RE: Development: Proposed Dublin Mountain Visitors centre

Location: Massy's Wood/ Montpelier Hill/ Hellfire Club

Applicant: South Dublin County Council

Reference No: JA0040

*Photographs
mentioned
in point
No 3(a).*

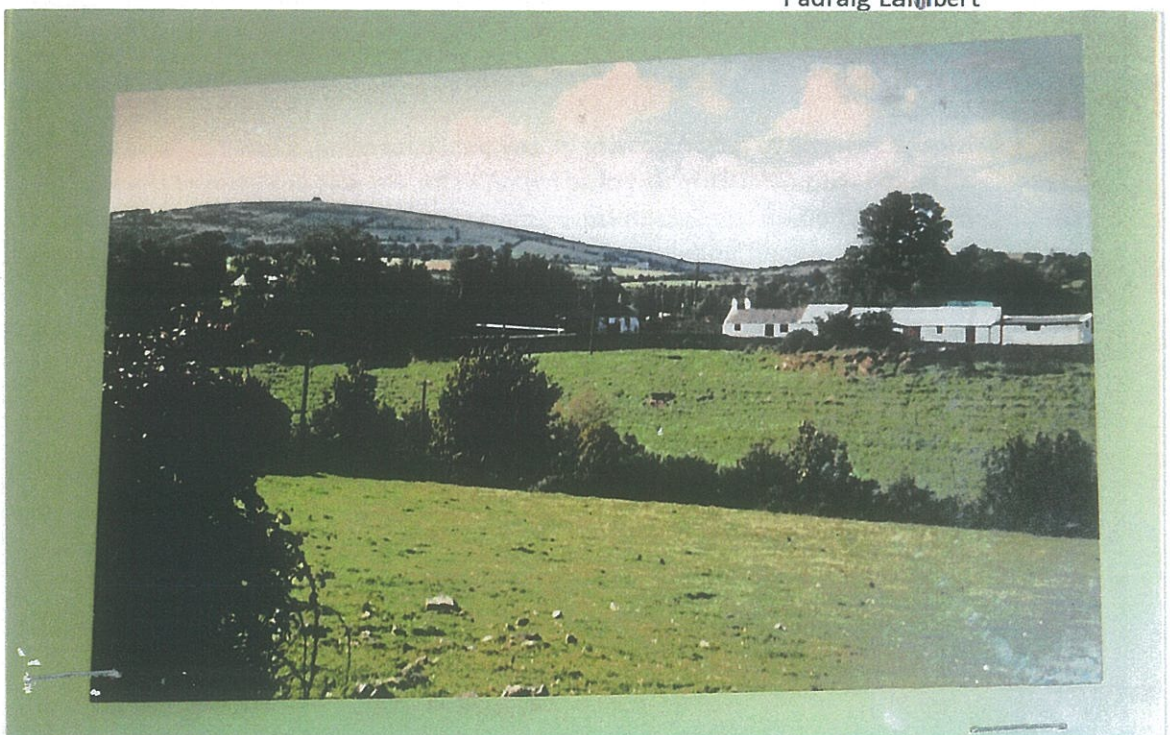
- (a) Paul Keogh architects for SDCC in his design report has a photograph on its cover showing the view of Dublin City but this is not taken from Montpelier Hill. It is from a different viewing point up at Killakee and is mis-leading! And I will refer to this photograph later in my objection.
- (b) Mr Keogh's report section 3.14 "Infrastructure and Services" says the surface run off from the car park will be piped under the R115 and into the Glendoo Brook. This is NOT Glendoo Brook. Glendoo Mountain is three mountains away.

(d) As already mentioned in my submission, the photo on the cover of the design report is a view overlooking the view of Dublin City beside a field rented by me. My farming difficulties are of people breaking fences, litter, trespassing and throwing empty beer glass bottles at my cattle which eventually leads to broken bottles which cattle walk on or machinery drive over. It is the same in my fields opposite Coillte Wood on Cruagh Road.

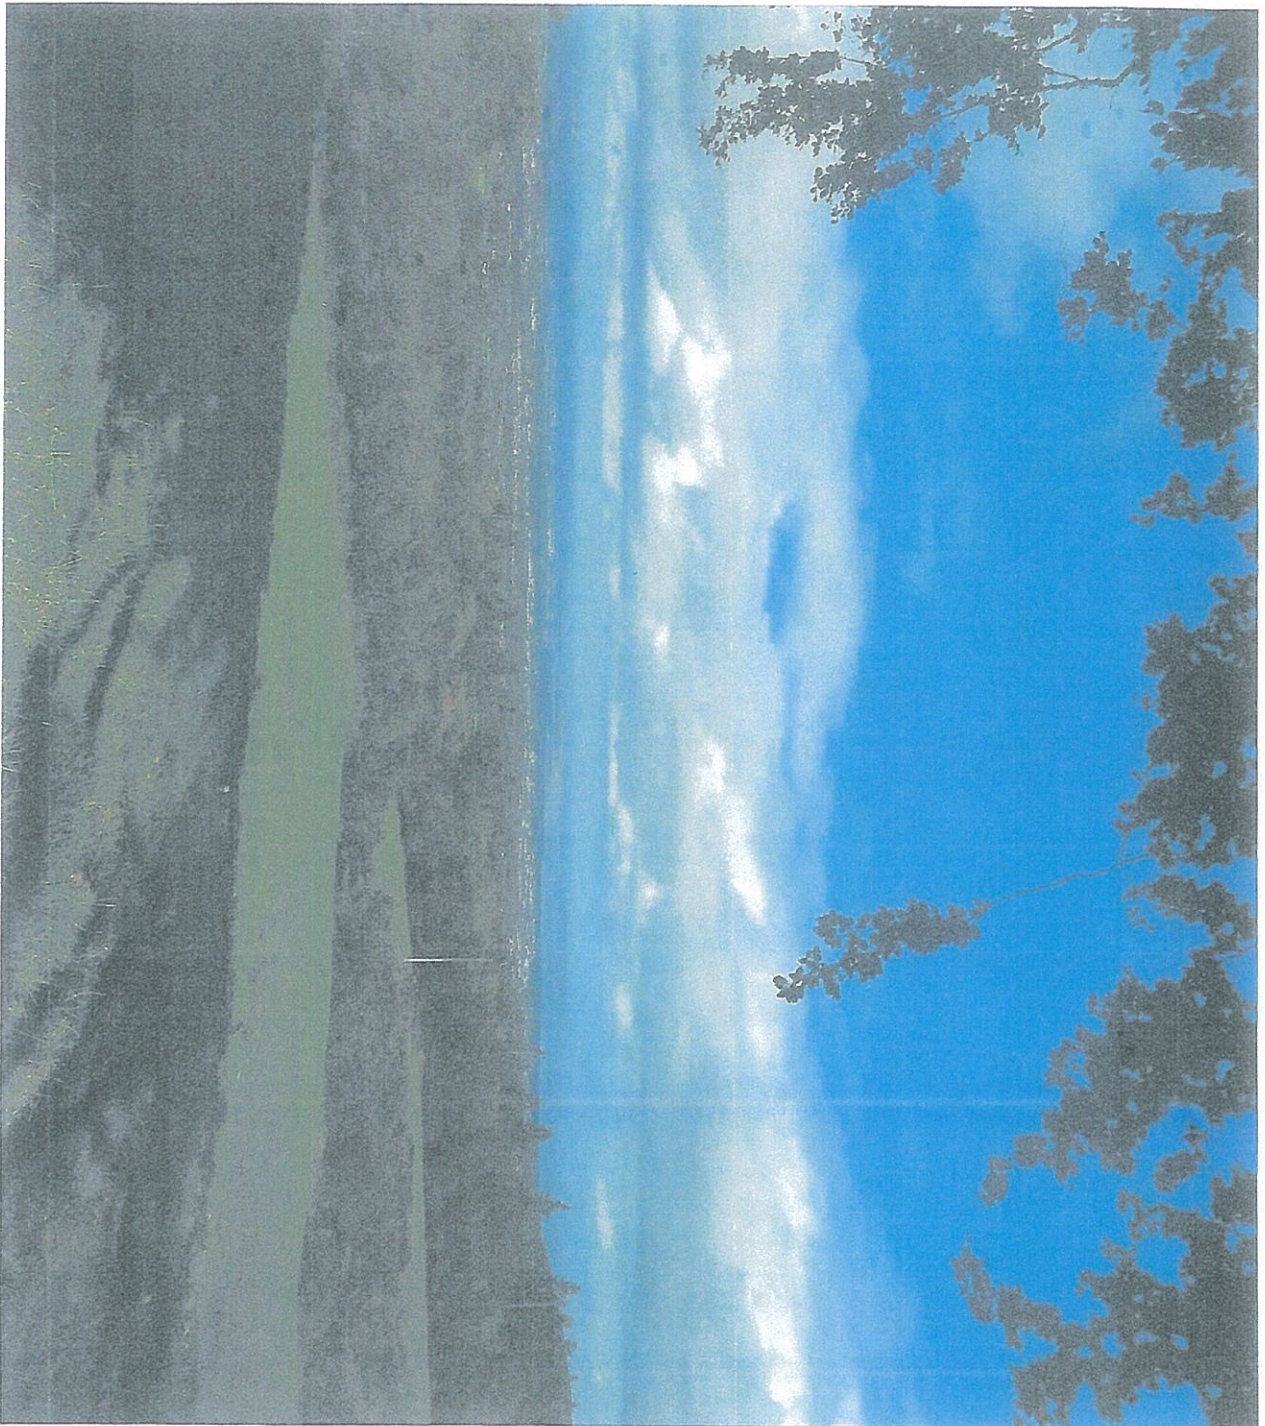
Finally, I will finish by saying a square building doesn't fit onto a round hill and leave you with an old photograph taken of the Hellfire Club in the early 1960's from the Tibbradden road when it was a bare hill with very few trees and the building itself stood out as a landmark.
